August 2017  
FL740A  
NHTSA #17V-402  
Transport Canada #2017-319

## Subject: Brake Check Valve

**Models Affected: Specific Freightliner 108SD, 114SD, and Business Class M2 vehicles manufactured December 16, 2014, through April 27, 2017.**

**Fig. 1, SR-7 Spring Modulation Valve**

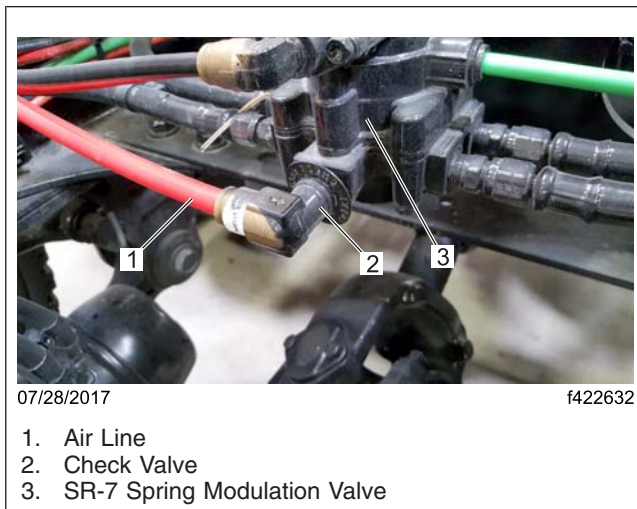
3. Locate the SR-7 spring modulation valve, shown in **Fig. 1**, and inspect the secondary air port for a check valve fitting. The check valve is integral to the fitting and will have the plastic tag that says 'check valve' on it. See **Fig. 2** for an example of the check valve.

1. Drain the air from the system.
2. Disconnect the air line. See **Fig. 1**.
3. Remove the fitting.
4. Install the new check valve fitting. See **Fig. 2**.
5. Connect the air line.
6. Start the truck to build air pressure in the system.
7. Using a solution of soap and water, test the air line for leaks. If bubbles appear, repair the leak as needed.
8. Clean a spot on the base label (Form WAR259). Write the recall number, FL740, on a completion sticker (Form WAR260), and attach it to the base label.
